ECN/PCN No.: 3448

Product Description: 32.768kHz SMD Crystal		Abracon Part Number / Part Series: ABS13	<input checked="" type="checkbox"/> Series
Affected Revision: K		New Revision: L	<input type="checkbox"/> Part Number
		Application	<input type="checkbox"/> Safety
			<input checked="" type="checkbox"/> Non-Safety

Prior to Change:

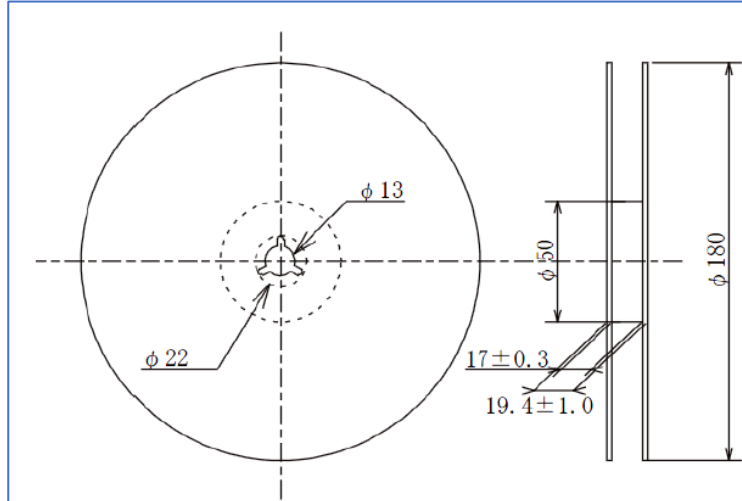
1. ROHS Statement
 - a. RoHS/Ro HS II compliant. Pb in high temperature solder (exempt 7(a) per RoHS II 2011/65/EU Annex)
2. Electrical performance
 - a. Frequency Coefficient (β):
 - i. Min = -0.040 ppm/T²
 - ii. Typ = -0.034 ppm/T²
 - iii. Max = -0.028 ppm/T²
3. Mechanical Dimensions (millimeters)
 - a. Side view; height dimension = 1.3 ± 0.1 mm MAX
 - b. Side view; lead/pad height dimension = 0.15 mm
 - c. Bottom view; lead/pad width dimension = 0.3 mm
 - d. Bottom view; lead/pad length dimension = 0.4 mm
 - e. Bottom view; length between pad #2 & #3 = 0.55 mm

4. Reel Packaging Dimensions (millimeters)
 - a. Top view; inner radial dimension = 13
 - b. Side view; outer radial dimension = $\varnothing 180$
 - c. Side view; inner radial dimension = $\varnothing 50$
 - d. Side view; outer height dimension = 19.4 ± 1.0 mm
 - e. Side view; inner height dimension = 17 ± 0.3 mm

After Change:

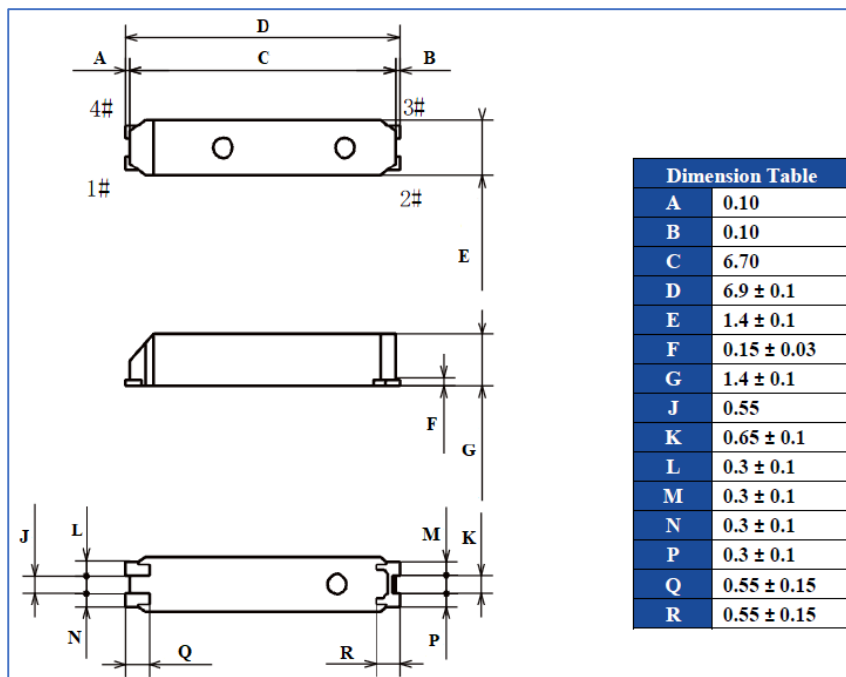
1. ROHS Statement
 - a. RoHS/RoHS II compliant. Pb in high temperature solder (exempt 7(a) per 2015/863/EU Annex)
2. Electrical performance
 - a. Frequency Coefficient (β):
 - i. Typ = -0.035 ± 0.01 ppm/ $^{\circ}\text{C}^2$
3. Mechanical Dimensions (millimeters)
 - a. Side view; height dimension = 1.4 ± 0.1 mm MAX (increase)
 - b. Side view; lead/pad height dimension = 0.15 ± 0.03 mm (increase)
 - c. Bottom view; lead/pad width dimension = 0.3 ± 0.1 mm (increase)
 - d. Bottom view; lead/pad length dimension = 0.55 ± 0.15 mm (increase)
 - e. Bottom view; length between pad #2 & #3 = 0.65 ± 0.1 mm (increase)

4. Reel Packaging Dimensions (millimeters)

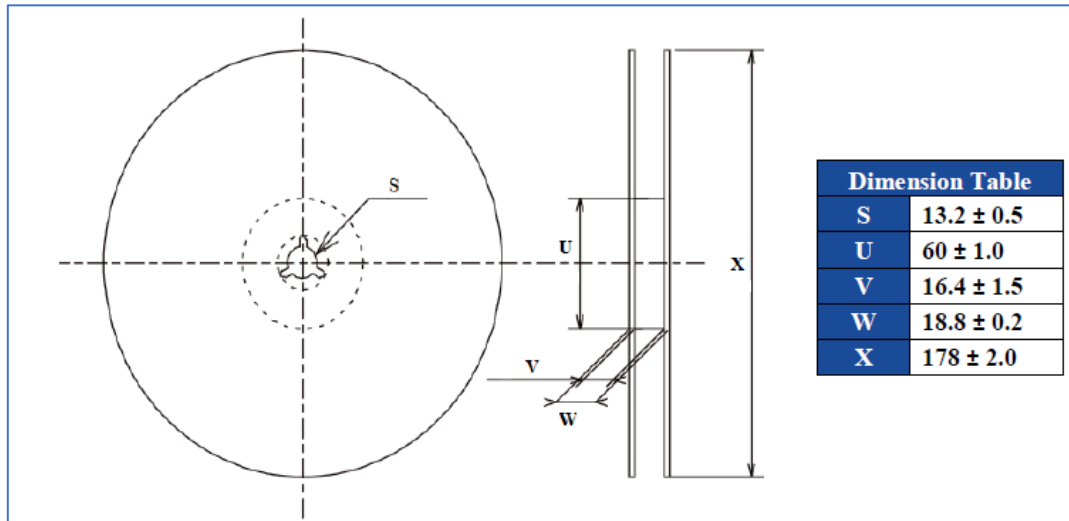
- Top view; inner radial dimension = 13.2 ± 0.5
- Side view; outer radial dimension = $\varnothing 178 \pm 2.0$
- Side view; inner radial dimension = $\varnothing 60 \pm 1.0$
- Side view; outer height dimension = 18.8 ± 0.2 mm
- Side view; inner height dimension = 16.4 ± 1.5 mm
